**King's Mark
Environmental
Review
Team
Report**

**PETER'S ROCK
SUBDIVISION
NORTH HAVEN,
CONNECTICUT**

Environmental Review Team Report

North Haven Inland Wetlands Commission

Figure 6

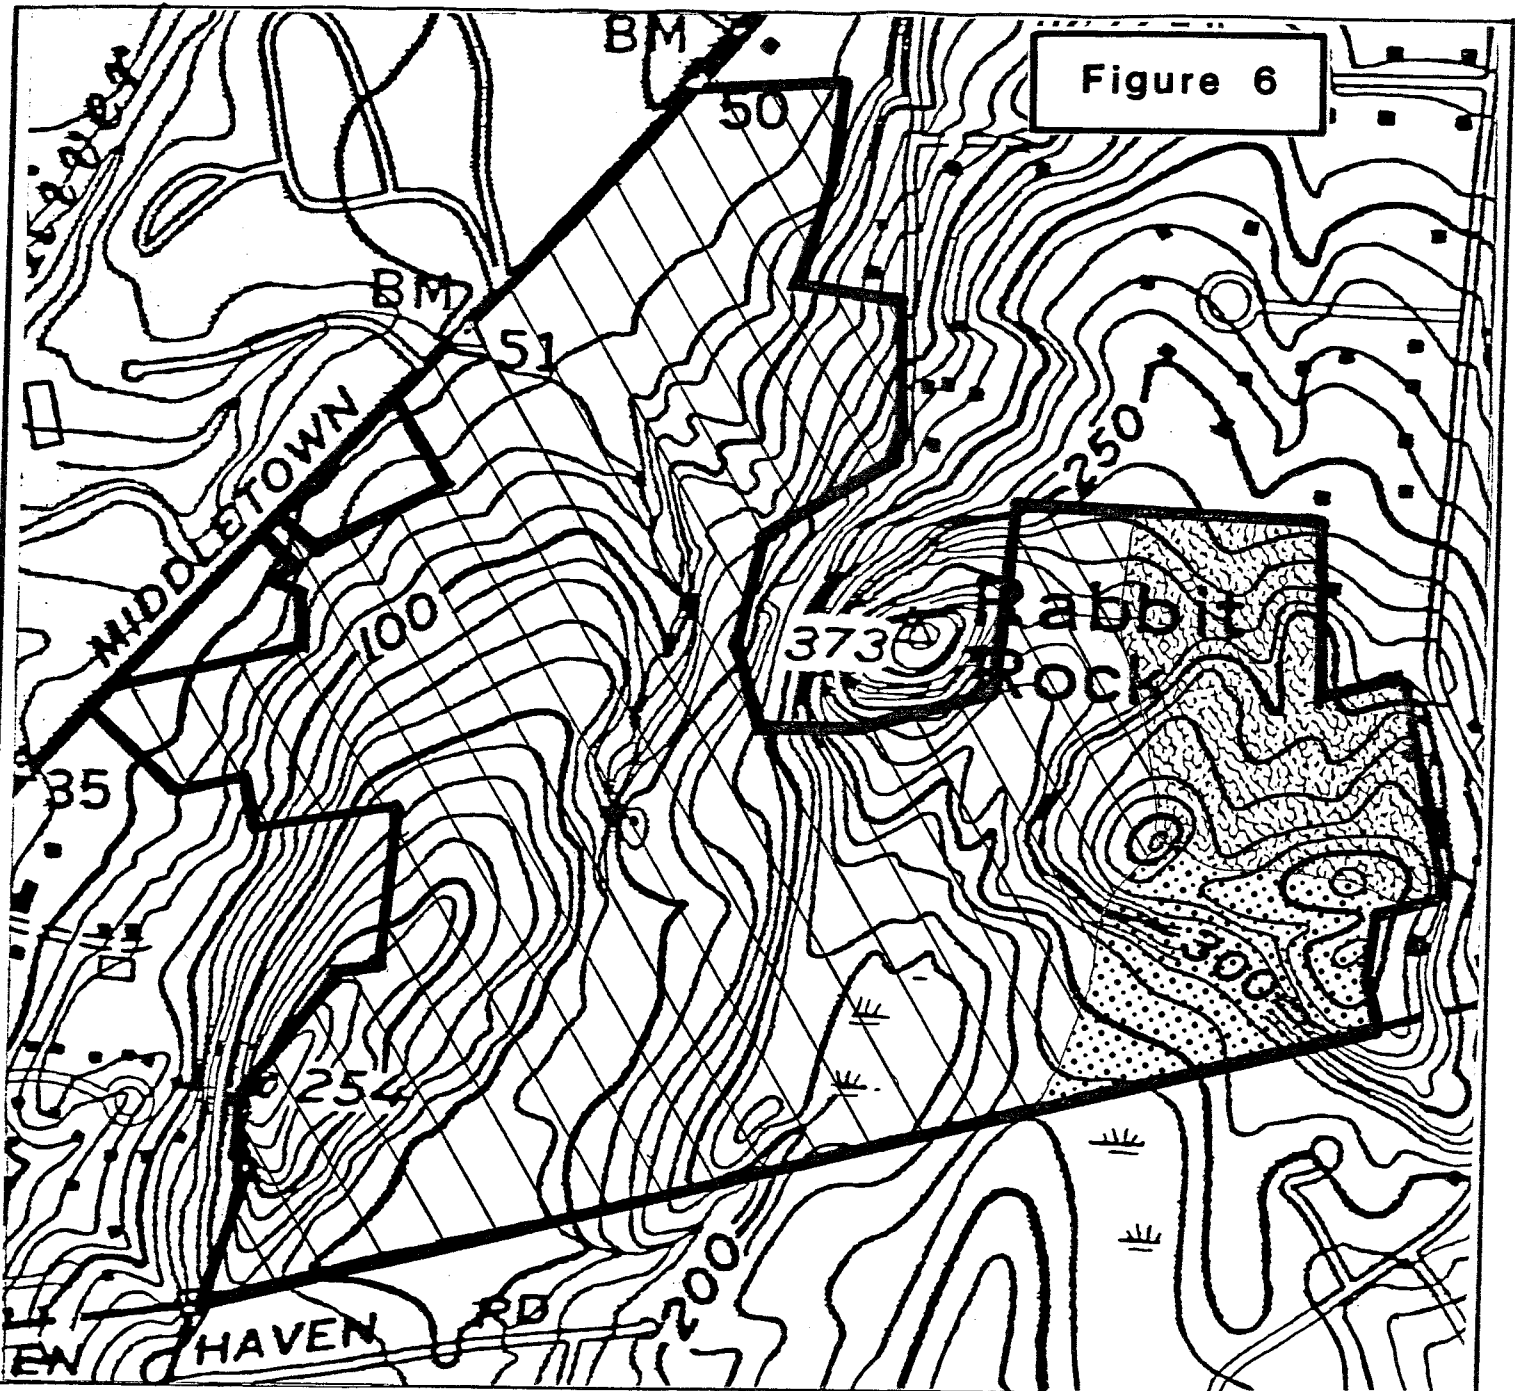
percent of the homes and respective road frontage proposed for the subdivision. An ideal hydrologic position would be at the northwest limits. If this is not feasible from an engineering standpoint, then the capacity of the proposed detention basins must be designed so that it compensates for runoff from the developed land in the drainage area, which cannot be detained by the basin. Close examination of all downstream culverts, especially the culverts passing under Route 17, is warranted.

All three detention basins are located on regulated inland wetland soils. Construction of the detention basins in wetlands will require a permit from the North Haven's Inland Wetlands Commission. Since the wetland areas already have some natural ability to detain stormwater flows, it would be desirable to keep detention basins on upland soils. The proposed detention basins may also be designed to function as a sediment basins. This should be given consideration so that sediment problems do not arise in streamcourses on and off the site. Maintenance measures should be included in the stormwater management plan in case a significant build up of sediments occurs during construction or from road sand accumulation from the roads following the construction period. There should be a determination made as to who will maintain the sediment basins. An access road for maintenance equipment to each basin should be shown on the final plan.

Figure 8

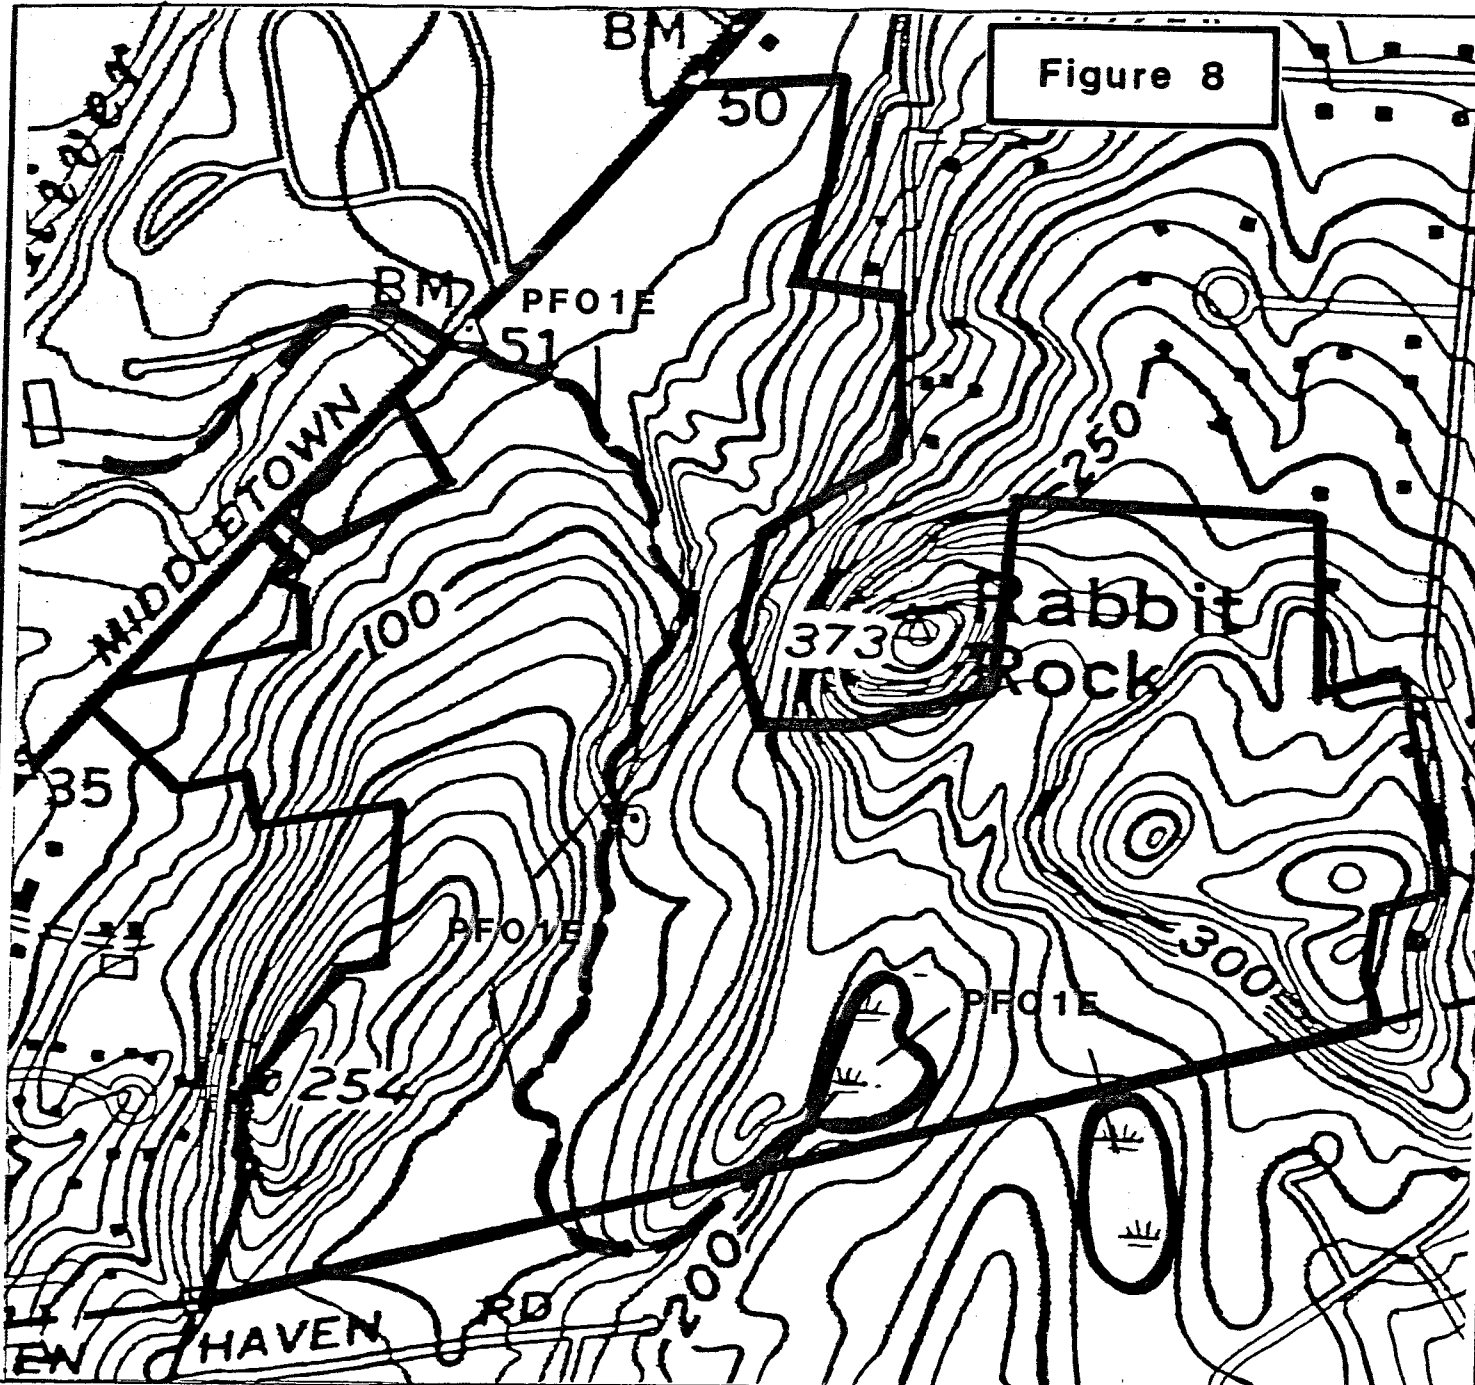
The impacts of this development on the wetlands would be significant despite the fact that the developer plans to deed all wetland areas to the Town of North Haven. The plans include the construction of two detention berms, a combined road crossing and detention berm, and three detention basins all within wetland boundaries. All of these activities will contribute to significant adverse impacts on the wetlands during and after construction.

The first berm will be constructed at the northern end of wetland area C. This berm will cross the opening of the ravine and be constructed to a height of approximately eight feet. This will result in an undetermined amount of wetlands filling and create potential for severe sedimentation problems within the ravine wetland and stream channel. This berm will also create the proposed detention basin #3 on the plans. Although developmentally practical, the creation of such basins within existing wetland areas is not a favorable activity for many reasons. The most obvious and detrimental impact will be an increase in the amount and type of pollutants which will enter the wetland. Increased runoff will also carry significantly larger loads of sediments, resulting in a need for continued monitoring of the basin, so that sediment accumulations can be removed whenever necessary. The combined effect of increased pollution and sediment loads into the wetland area will eventually produce a change in the overall character and quality of the wetland. This can be noticed by changes in plant species and diversity as well as reductions in wildlife populations and frequency of sightings.

The second berm will be constructed in the southwest corner of wetland area D. This berm will be approximately six feet in height and be constructed across the outlet of this wetland area. Again, the impacts of this berm will be much like those described above. In both cases culverts will be placed at the base of the berm to allow for the controlled outlet of water.

The combined road crossing and detention berm will be constructed in the middle of wetland area C, bisecting it into detention areas #3 and #2. The crossing will be approximately 6 feet high, 40 feet wide and 210 feet across. The construction of this crossing will have significant impacts beyond those mentioned with respect to the berm constructions. The placement of this crossing in a high quality wetland and its interruption of the existing natural corridors increase its impacts. Apart from the obvious increase in fill area, this crossing will create a physical barrier to wildlife. Culverts will be installed to control water flows, but these will not provide adequate corridors for wildlife movement through the area.

- (1) The use of box culverts for the crossing of wetland area C is highly preferred, so as to limit long-term disturbance to the habitat corridor. Box culverts with natural bottoms would provide a less intimidating barrier to the movement of small mammals and invertebrates. Crossings of this type would also maintain the natural water flow rates and allow the wetland to perform natural flushing of sediments and debris during storm events without any ponding of water. This recommendation is based on the question as to whether the proposed detention basin #2 is actually needed for adequate flood control on site. If ponding were to occur because of the use of smaller culverts this could alter the natural character of the corridor and would result in increased sediment and debris accumulation.

- (2) Due to the high percentage of wetlands which exist on lots 2 and 5 in combination with the town's set back requirements from roadways, it is recommended that the elimination of these lots as building sites be seriously considered.

- (3) The proposal shows no attempt on the part of the developer to create new wetland areas to compensate for wetlands lost due to fillings. Proposals of this magnitude often include such measures as mitigation for wetland area and functions lost to development.

- (5) Alternatives to constructing the detention basin within existing wetlands should be thoroughly explored. Construction of such basins within wetlands create potential for adverse changes in wetland character (vegetative types, water regime, sediment filtration functions, wildlife diversity, etc.) and quality.

- (7) Due to the size and function of the proposed detention berms, it is recommended that the applicant submit comprehensive plans to the Water Resources Unit, Dam Safety Section, of the DEP. Such plans should include complete construction specifications, hydrologic data and building materials in order to determine if a dam permit will be required for construction.

Figure 11

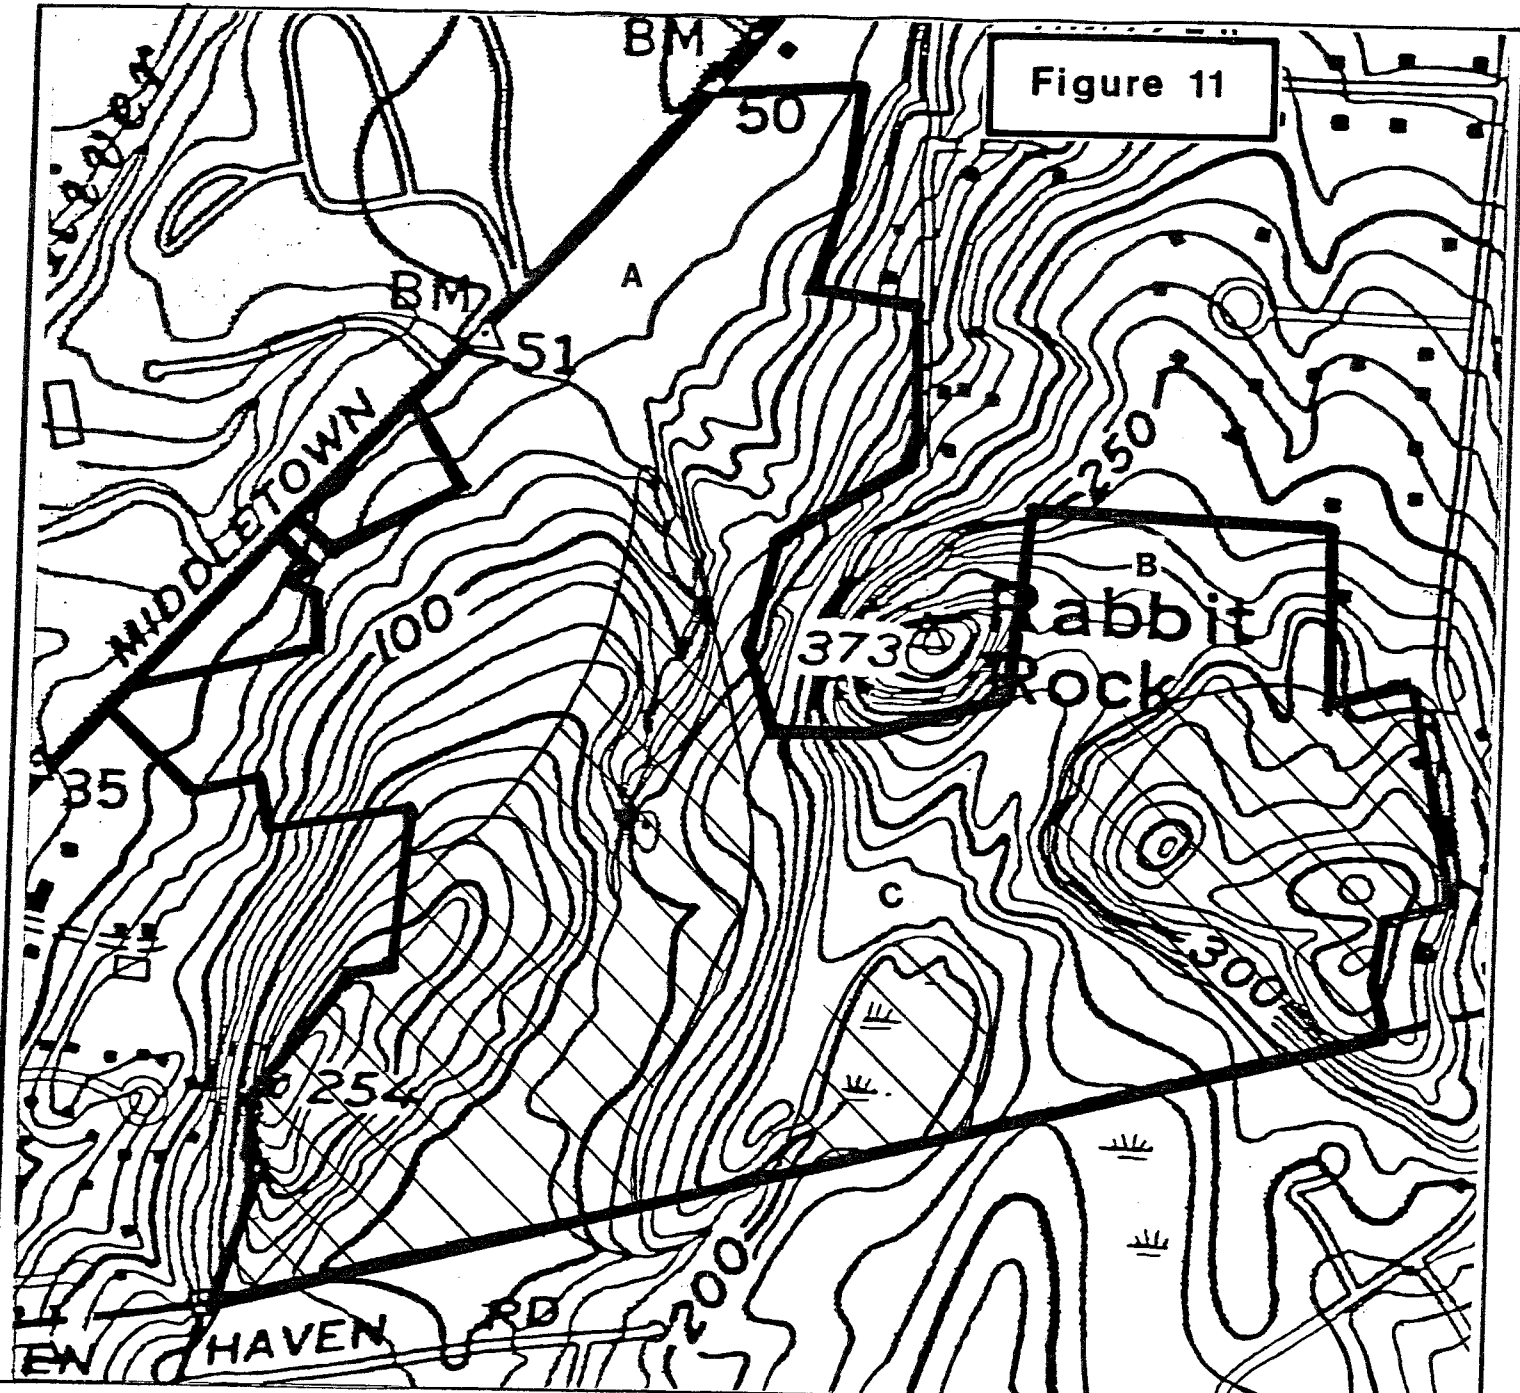
Nevertheless, imposition of such a plan on a property with extensive areas of steep slope (+15%), rock outcrop and wetland is not desirable both in terms of environmental impact and cost of development.

A cluster approach might be preferable with a property of this type. Such a plan would avoid areas with site development problems as sketched in Figure 11, with such areas to be dedicated as permanent open space. Development, perhaps of semidetached condo variety, could be concentrated largely on the more readily developable land in the northwest portion of the property (A on map). Perhaps a higher density townhouse condo approach could be used in proximity to Route 17 to help offset the loss of other acres as open space. Feeder roads could also lead to clusters of condos on other pockets of good land south and east of Peter's Rock/Rabbit Rock (B and C on map).

A plan of this general type could result in a very handsome neighborhood which combined good design with retention of the area's natural features. Costs of construction and continuing maintenance could be cut substantially by the decreased need for blasting and for decreased mileage of roads and water and sewer utilities. Such a development approach could perhaps obviate, or at least decrease the need for retention basins.
